HUMAN ECOLOGY BUILDING & WARREN HALL  
PEDESTRIAN ACCESS PATH IMPROVEMENTS

## **ADDENDUM NO. 1**

January 16, 2026

### 1 RESET GRANITE SLABS ON CONCRETE BASE

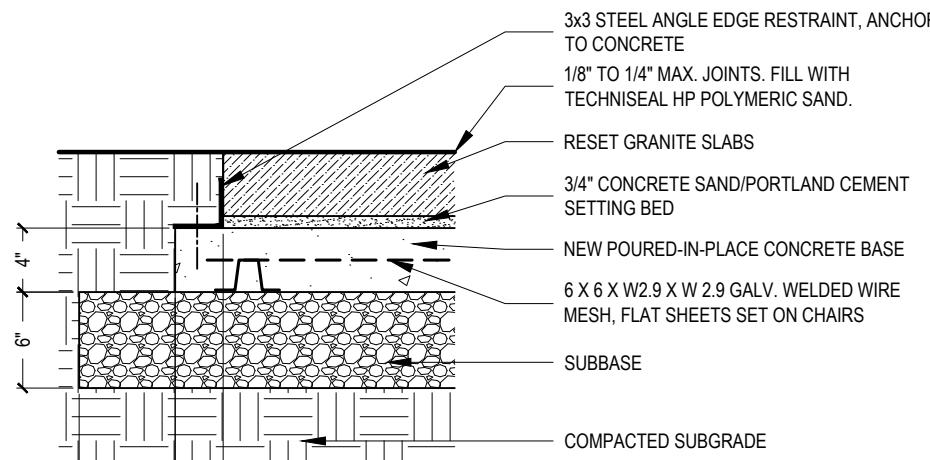
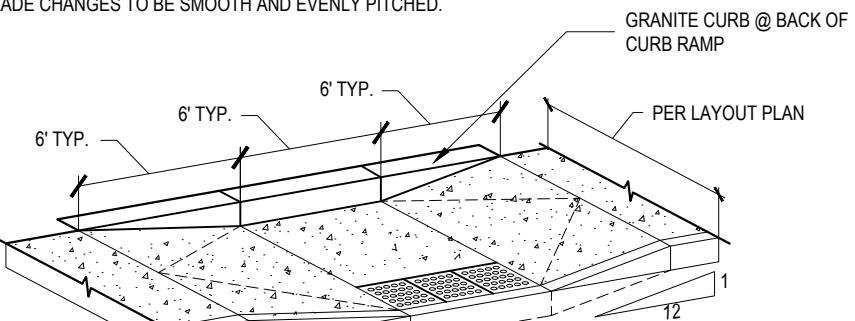
RFI/ Response Index	Page/ Dwg./Spec./Rep. Number	Section/ Paragraph/Topic	RFI	Design Team Response
1	L3.1	Detail 1	There is no demo detail for the Warren Hall entrance way. Detail 1 on L3.1 calls for the removal, stockpiling and resetting of existing 4" thick granite slabs. However the picture on Detail 2 on L3.1 clearly shows a concrete surface at the entrance. Is this concrete to be removed and replaced with new granite slabs (pavers)?	The granite slabs are set on granular setting bed.
2			Please confirm that the existing pavers to be stockpiled and reset at the Warren Hall entry way are currently set on grade, and not on an existing concrete base that needs to be removed.	The granite slabs are set on granular setting bed.
3			There's a fire hydrant adjacent to the existing pathway in front of the Human Ecology Building that isn't mentioned on the layout plan, or the grading plan. What is the impact and/or expectation for this fire hydrant relative to the new concrete sidewalk?	The existing fire hydrant is to remain and be protected.

1. CONTRACTOR TO REMOVE, CLEAN, AND STOCKPILE EXISTING GRANITE SLABS FOR REINSTALLATION.
2. IF EXISTING SLABS ARE BROKEN, CRACKED, OR OTHERWISE DAMAGED, CONTRACTOR SHALL PROVIDE IN-KIND REPLACEMENT SLABS TO MATCH, AT NO ADDITIONAL COST TO OWNER.
